# THE CITY OF DURHAM TRUST

11 February 2023

**DM/22/03778/FPA: Hybrid planning application consisting of outline planning permission (all matters reserved) for an extension to the Sniperley Park and Ride, and full planning permission for the development of 368 dwellings, associated access and works, and demolition of former farm buildings (resubmission).**

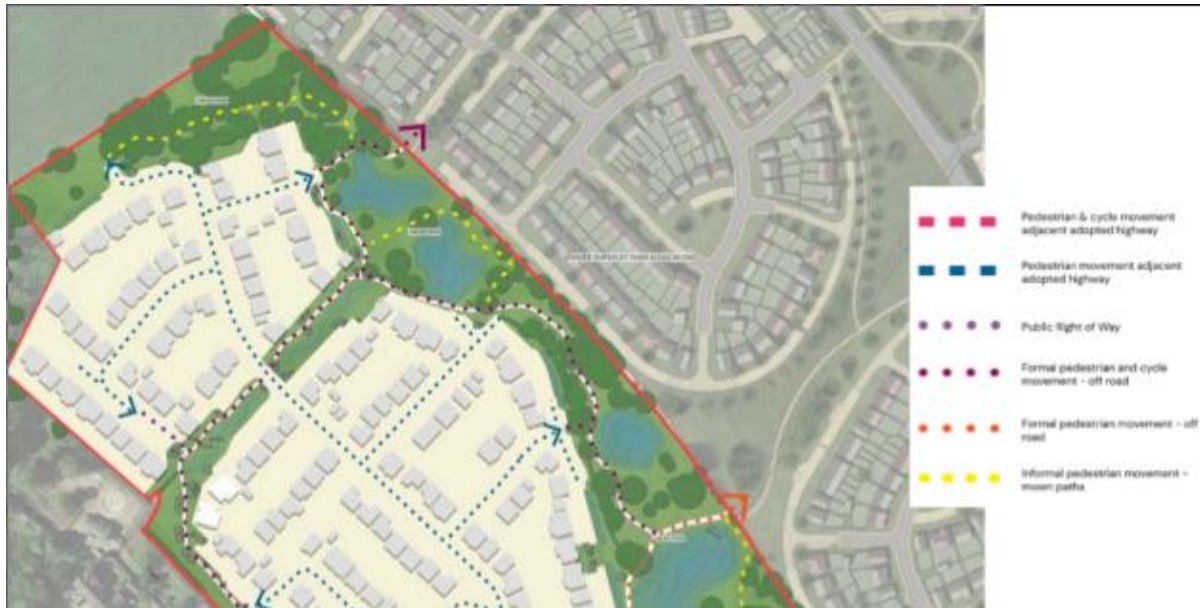
In the Bellway layout, shown below in the Adoptable Highways Plan, somewhat narrower park areas are provided, but the Sniperley Hall Street in between, with its community focal point on the access road, is omitted. The only cycle link shown (in purple) is near the power lines. In the Adoptable Highways Plan the link at the northern end of the site is just for pedestrians.

Page 97 of the Design and Access Statement (see excerpt on the next page) shows the link at the northern end as a cycle route but the path near the power lines is this time pedestrian only. The Adopted Masterplan requires a coherent layout across the whole site, interconnected by direct and legible cycling and walking routes.

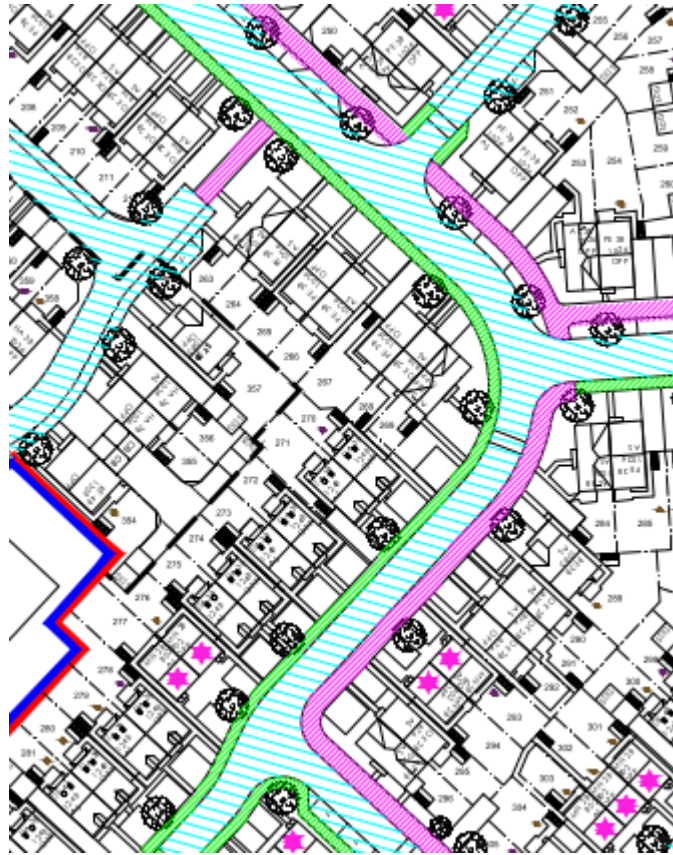
There are various unfortunate inconsistencies in the documentation provided. The Adoptable Highways Plan shows cycleways in pink, footways in green, and footpaths in brown. The Movement Hierarchy Plan uses a different notation, and differs in omitting the off-carriageway cycle link to the Park and Ride. The Proposed Layout Sheet 1 labels the path leading out of the north end of the site “Cycle path connection to adjacent scheme” but on the other two plans this is indicated as pedestrian only. Page 97 of the Design and Access Statement swaps the labelling of the paths, making the north end link the only cycle path. The Transport Assessment, Figure 11, shows a cycle path running NW from the crossing of the main access road along the edge of the site by Sniperley Farm, and ending by the access road to the NW portion of the development. This is not shown as a cycleway on any of the other plans. At 2.0m wide it would not comply with LTN 1/20, and this is perhaps why it has been omitted from the cycle network.

It is quite clear that people are very likely to wish to access a number of these routes by cycling. They should be redesigned to be a minimum of 3.0m wide. In particular the route parallel to the electricity pylons, which will be the shortest route to the primary school, should be upgraded in width. The route from the north end of the site, which is likely to be the shortest route to the local shops on the B6532, should also be upgraded for cycling. A third link, along the alignment of the Masterplan's “Sniperley Hall Street” should also be provided. This will entail redesigning the road layout.

## Apartment blocks

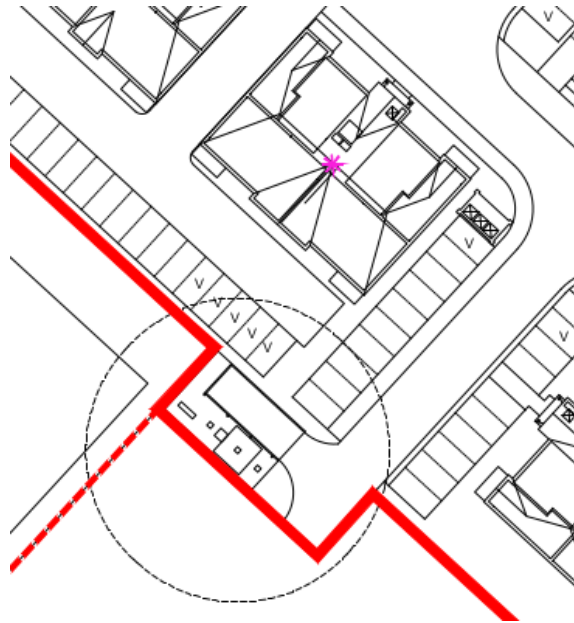
The plans for the Beekeeper and Honeyman apartment blocks do not show any cycle parking on the ground floor of the block. Without proper provision residents may be tempted to use some of the stairwell space on each floor to store bicycles, and this could be a risk during a fire evacuation. On the Proposed Layout drawings there are some rectangles close to the buildings but it is not clear if these are secure cycle parking (e.g. lockable hangars).

It is not clear whether the intention is for residents of the apartments to use the public “cycle hub” or whether private cycle parking is provided for their use. If the cycle hub is publicly accessible, what will the security arrangements be?
